Tallawarra Stage B Gas Turbine Power Station

SUBMISSIONS REPORT

- March 2010

■ *Figure 2 - Schematic of proposed operation*

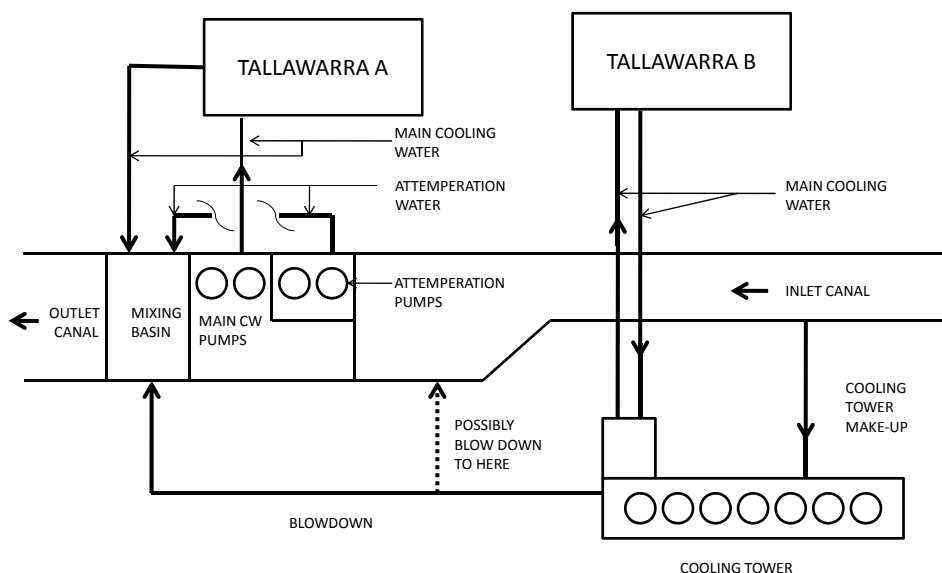
The Submissions Report should present a method which uses an approved product or an alternative treatment methodology for biofilm control and assess the worst case impacts associated with its use.

Figure 2 shows a sketch of the proposed cooling water arrangements for Tallawarra Stage B. The concept design is for the blowdown from the Tallawarra B cooling tower to be released to the mixing basin at the outlet from the Tallawarra A cooling system. Alternatively, the blowdown could be released into the inlet canal before Tallawarra A.
